**BEFORE THE PUBLIC UTILITIES COMMISSION**

| Order Instituting Rulemaking to Implement Electric Utility Wildfire Mitigation Plans Pursuant to Senate Bill 901 (2018). | Rulemaking 18-10-007<br>(Filed October 25, 2018) |

# COMMENTS OF THE UTILITY REFORM NETWORK ON 2021 WILDFIRE MITIGATION PLAN UPDATES

March 29, 2021

**Figure 1– 2020-2022 WMP Spending Per Customer for Large Utilities[33]**

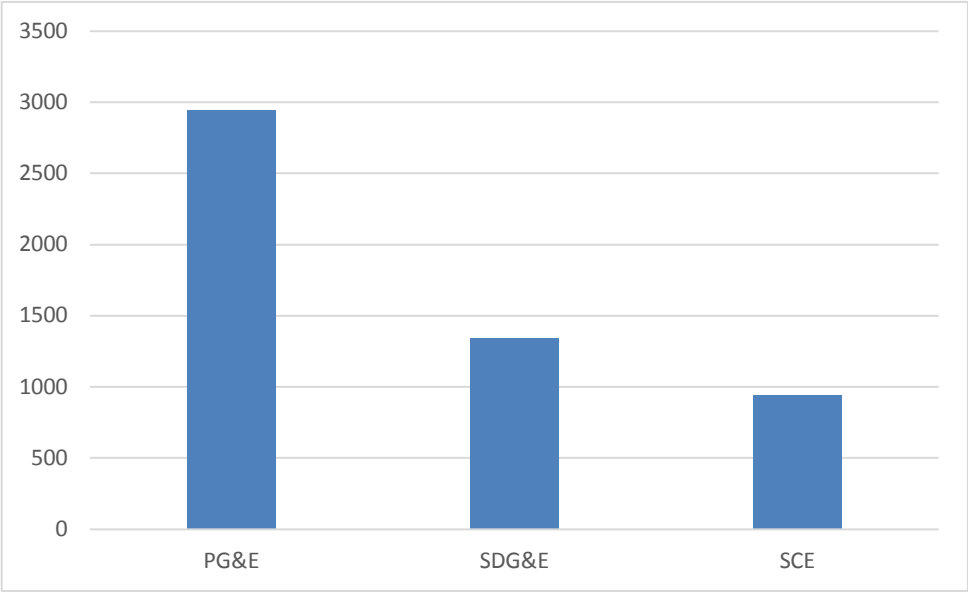
With respect to total WMP spending for 2020-2022 (recorded and planned), PG&E's per customer spending significantly exceeds that of Southern California Edison (SCE) and San Diego Gas and Electric (SDG&E), as shown in the figure below.

Thus, PG&E is on pace to significantly outspend its peer utilities even taking into account differences in utility size, miles of overhead other facilities, and prevalence of red flag warning conditions.

**Figure 2: Annual Ignitions by Driver, PG&E, Average for 2015-2020[94]**

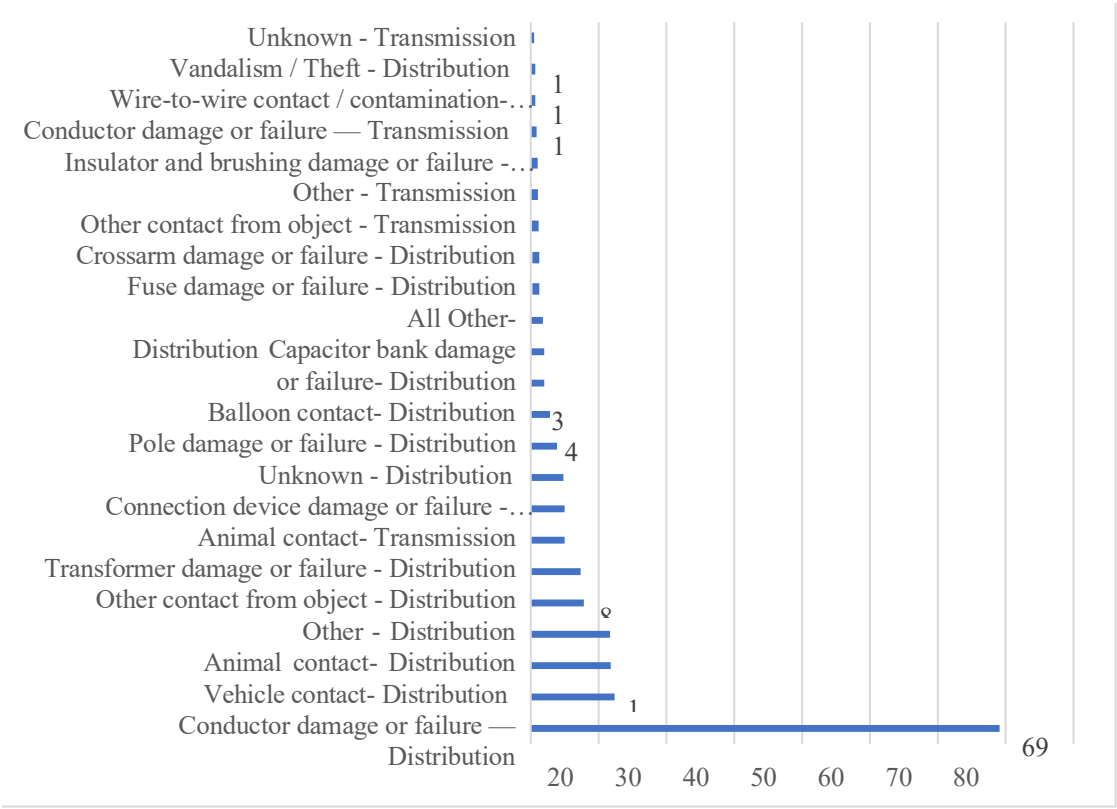
Another likely explanation for the extremely high cost of PG&E's (and likely also SDG&E's) covered conductor program is that PG&E is replacing many other existing useful assets as part of overheard grid hardening. PG&E has failed to justify the need to replace all other assets – including fuses, switches, crossarms and mineral oil transformers - as a necessary component of system hardening. PG&E has argued in general that replacing all assets with "exempt" equipment reduces ignition risk. However, PG&E does not track risk mitigation at the "activity level."[93] Historical ignition data in PG&E's Table 7.2 show that the risk of ignitions from most of these assets is trivial.

As shown in the Figure, the failure of assets such as fuses, crossarms and poles causes less than three ignitions per year. Reclosers and switches caused zero ignitions from 2015-2020, yet PG&E replaces them under overhead hardening guidelines.[95] Moreover, all transformers are exempt,[96] so there is no apparent justification for wholesale replacement of transformers. Calculations presented in the RAMP proceeding illustrate that the RSE for crossarms and transformers is a factor of ten lower than the RSE for covered conductor or fuses/switches.[97] The bottom line is that PG&E has devised a completely new design standard for its HFTD

**Figure 3: SCE Risk Curve[122]**

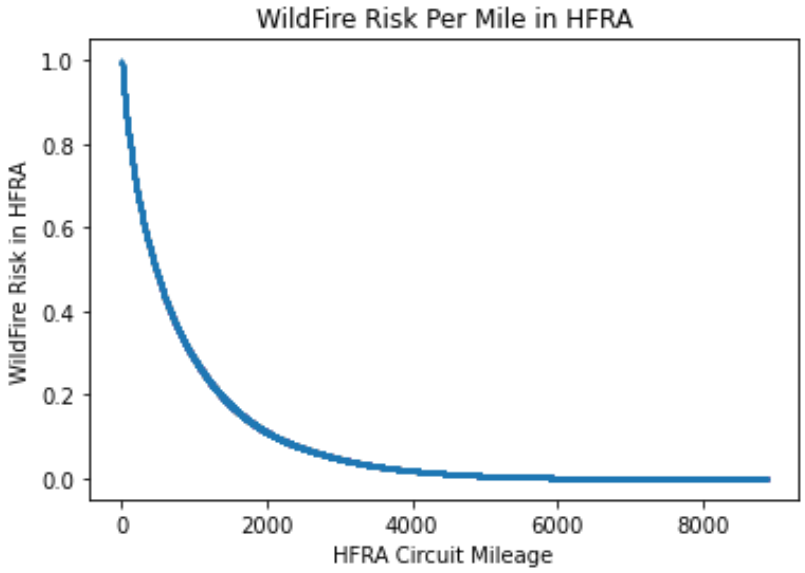
The figure below is the "risk curve" "generated by ranking all conductor segments from highest to lowest risk."[121]

The horizontal axis of the curve shows cumulative HFRA circuit miles and the vertical axis "represents the sum of all the wildfire risk in terms of both probability of ignition and consequence for circuit segments in the HFRA."[123] The risk curve is steeper from 0-2,000 HFRA circuit miles, when it begins to flatten out, meaning that risk is more concentrated in the first 2,000 HFRA circuit miles. As shown by the arrow in the figure above, SCE's proposed scope of covered conductor during the WMP term would address risk after the risk curve begins

Ex. TURN-02 Figure 5 Wildfire Risk v Cumulative HFRA Miles; SCE GRC Risk Analysis[290]

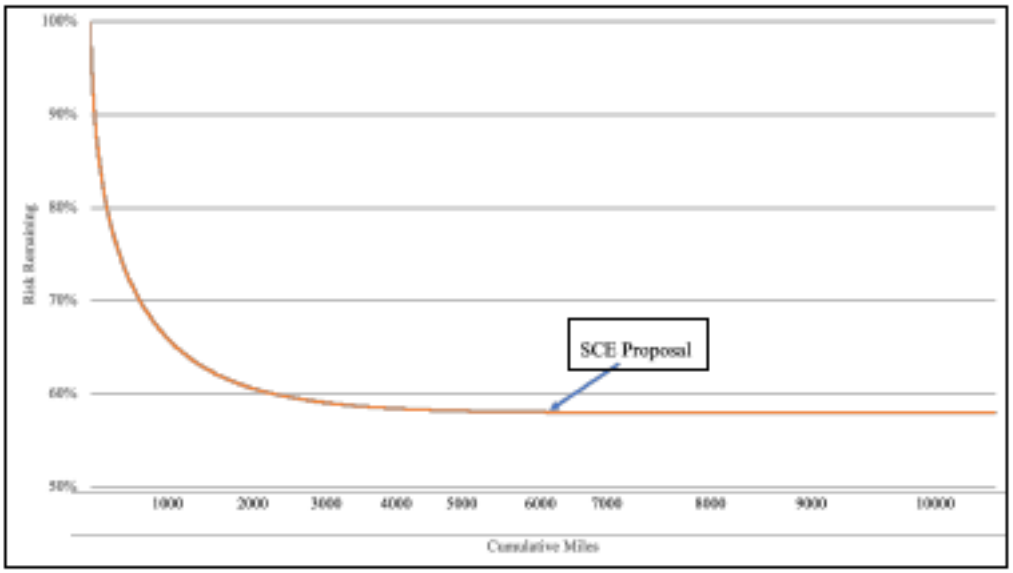
SCE's deployment prioritization model illustrates that risk is not consistent from circuit to circuit, and, indeed, SCE intends to address the highest risk segments first.[288] If each circuit has a different risk profile, but hardening costs are consistent from circuit to circuit, the cost efficiency of hardening each circuit will vary. Riskier circuits will be more cost-efficient to address, with cost-efficiency declining with each relatively less risky circuit. In Figure 5,

The steep decline in Ex. TURN-02 Figure 5 demonstrates that SCE's highest risk segments are fairly concentrated. As the slope begins to flatten, each additional mile is less risky on a relative basis. TURN's proposed program focuses ratepayer spending on those circuits that present the most risk.

Ex. SCE-15, Vol. 5: Figure II-3 Overlay of Historical Large Fire Events on SCE's Relative Risk Buydown Curve[314]

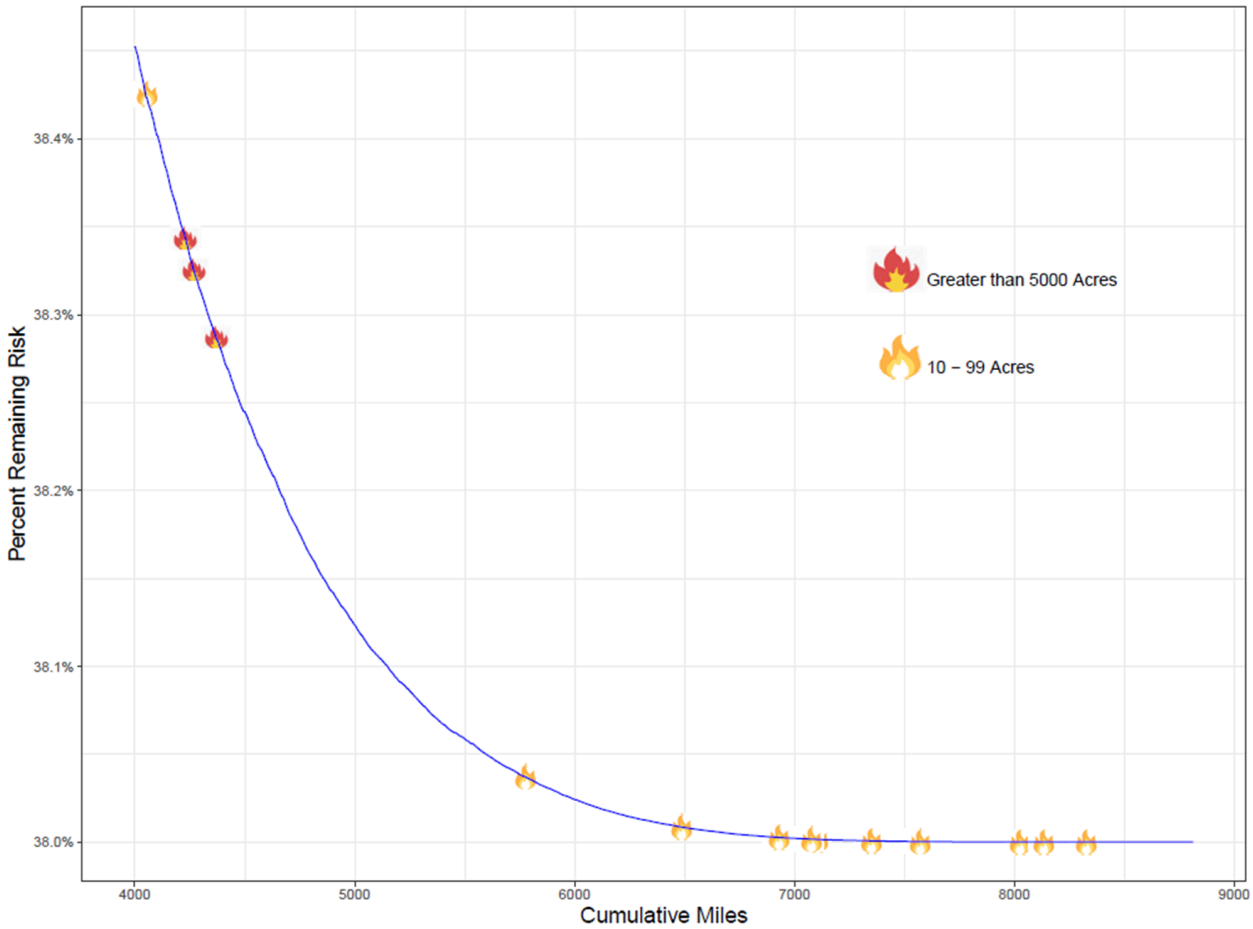
As an initial matter, and for purposes of clarification, each fire icon represented in the figure does not necessarily represent a separate fire, each icon instead represents an impacted circuit.[315] Figure II-3 reflects two fires greater than 5,000 acres and seven fires impacting between 10 and 99 acres.

efficient use of ratepayer dollars consistent with just and reasonable rates to deploy covered conductor to circuits at such relatively low points in the risk buydown curve. TURN fully expects other wildfire risk mitigations to be deployed here, as discussed above. As the y-axis of SCE's Figure II-3 demonstrates, the circuits shown represent between 38 and 38.5 percent of remaining wildfire risk. In other words, TURN does not believe it is just, reasonable, necessary, or efficient to spend $421,000 per circuit mile to potentially buy down less than 0.5% of remaining wildfire risk. SCE's Rebuttal demonstrates the utility has effectively ignored affordability constraints in lieu of arguments that ratepayer funds must be expended subject only to the limits of SCE's resources.
